Access Compliance Report

Public Rights-of-Way

(Curb Ramps)

Intersection ID: 7604	Main Street: KISMET_DR	Cross Street: SULLINS_RD	Location: S
ADA ID: 4F02C4C98865	Ramp Type: Perp	Initial Pass/Fail: Fail	Overall Compliance: No
Severity Score: 8.75			
Codes/Mitigation Info/Possible Solution		Field Measurements/Component Compliance

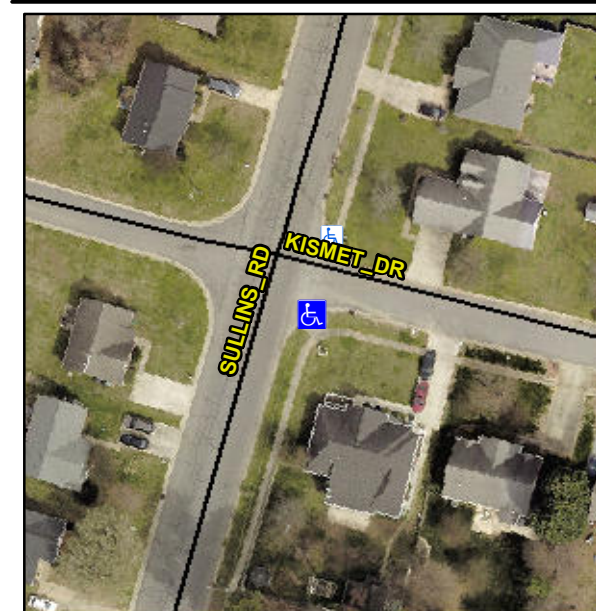
Not Found, R304.5.1

Compliance	Description	Data	Compliance	Description	Data
N/A	Ramp Length (in)	101.0	Yes	Ramp Slope (%)	5.0
No	Ramp Width (in)	45.0	Yes	Ramp XSlope (%)	1.4
N/A	Flare Type LT	N/A	N/A	Flare Type RT	N/A
N/A	Flare Slope LT (%)	N/A	N/A	Flare Slope RT (%)	N/A
N/A	Flare Traversable LT?	N/A	N/A	Flare Traversable RT?	N/A
N/A	Landing Length (in)	N/A	N/A	DWS Provided?	N/A
N/A	Landing Width (in)	N/A	N/A	DWS Contrast?	N/A
N/A	Landing Slope (%)	N/A	N/A	DWS Length (in)	N/A
N/A	Landing X Slope (%)	N/A	N/A	DWS Full Width?	N/A
N/A	Landing Curb? (Y/N)	N/A	N/A	DWS Offset (in)	N/A
N/A	Shared Landing?	N/A			
N/A	Gutter Ponding?	N/A	N/A	Gutter Slope (%)	N/A
N/A	Gutter Lip Ht (in)	N/A	N/A	Gutter X Slope (%)	N/A
N/A	Painted X Walk1?	No	N/A	Painted X Walk2?	N/A
	X Walk 1 Direction	To N		X Walk 2 Direction	N/A
N/A	X Walk 1 Width (in)	N/A	N/A	X Walk 2 Width (in)	N/A
	X Walk 1 Slope (%)	0.8		X Walk 2 Slope (%)	N/A
	X Walk 1 X Slope (%)	3.4		X Walk 2 X Slope (%)	N/A

Remove & Replace Entire Ramp.
